R.E. Ginna Nuclear Power Plant
Facility Operating License No. DPR-18
NRC Docket No. 50-244

Subject: Revised Nuclear Emergency Response Plan

Summary of Changes - 10 CFR 50.54(q)(5)

FIGURE 5.2 EVACUATION ROUTES

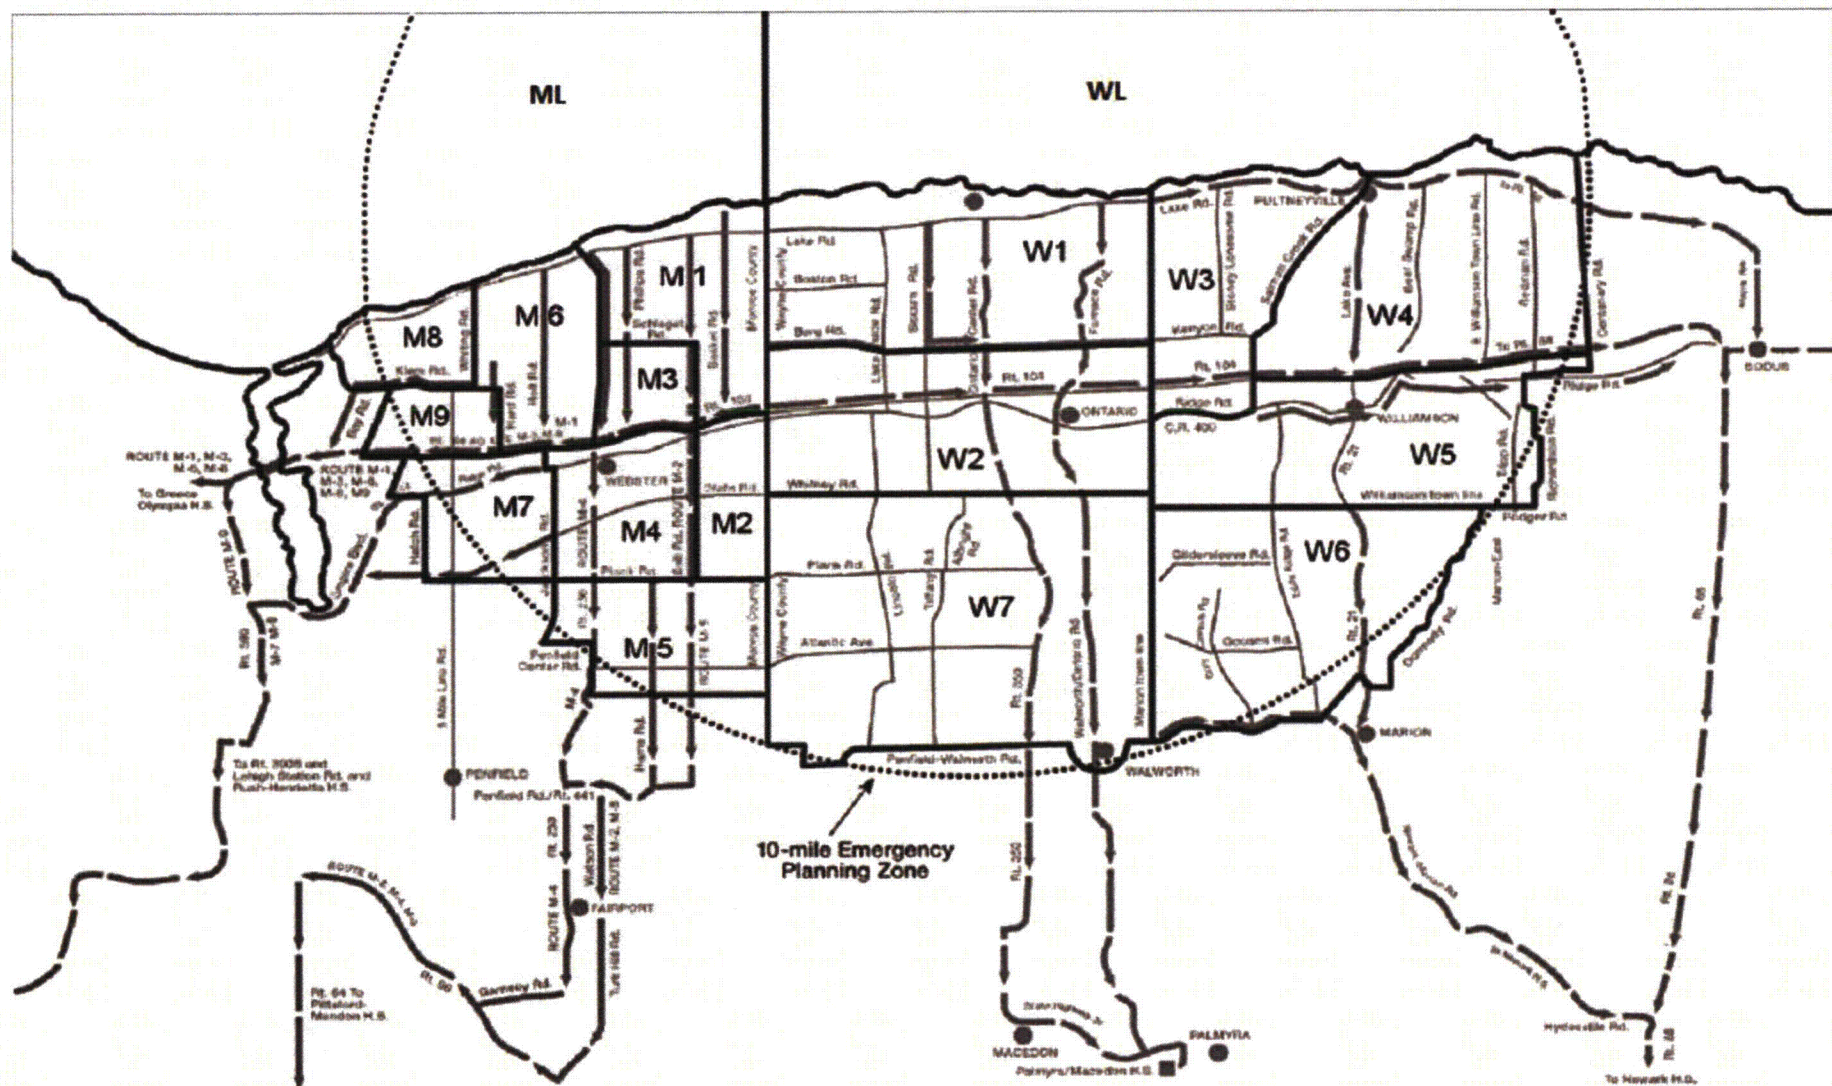
Document ID	NERP	Change Number	2014-064-01
Document Title	Ginna Station Nuclear Emergency Response Plan		
Change Description	<p>The diagram in Figure 5.2 will be amended to show the designation of the two new Emergency Response Planning Areas (ERPAs) on Lake Ontario.</p> <p>The existing Figure 5.3, Scheme for Protective Action Recommendations (PAR) will be replaced with the new PAR scheme developed by Exelon corporate for implementation of the new revision of NUREG 0654, Supplement 3.</p>		
Editorial Basis	NA		
EP ELEMENT/FUNCTION APPLICABILITY CONCLUSION			
The change does not adversely affect associated 10CFR50.47(b) planning standard functions, or program elements from NUREG-0654/FEMA-REP-1 Section II.			
BASIS FOR CONCLUSION	<p>A range of protective actions has been developed for the plume exposure pathway EPZ for emergency workers and the public. In developing this range of actions, consideration has been given to evacuation, sheltering, and, as a supplement to these, the prophylactic use of potassium iodide (KI), as appropriate. Guidelines for the choice of protective actions during an emergency, consistent with Federal guidance, are developed and in place, and protective actions for the ingestion exposure pathway EPZ appropriate to the locale have been developed.</p> <p>Implementation of NUREG 0654, Supplement 3 does not result in a reduction in the effectiveness of the Emergency Plan or it's implementing procedures. The Plan and procedures:</p> <ul style="list-style-type: none">• Provide a range of protective actions including sheltering, evacuation and KI where applicable.• Implement protective actions for hostile actions.• Utilize the Evacuation Time Estimates in determining staged evacuation requirements or actions taken during a Rapidly Progressing Severe Accident• Maintain compliance with all Federal guidance, namely Supplement 3.• Do NOT implement any PAR process that would relax PARs that have already been relayed to the OROs and are being implement by the public• Do NOT implement any PAR process that would restrict the most effective PAR to be implemented.• Do NOT change the dose assessment computer programs that results in a reduction of the options available to perform assessments.
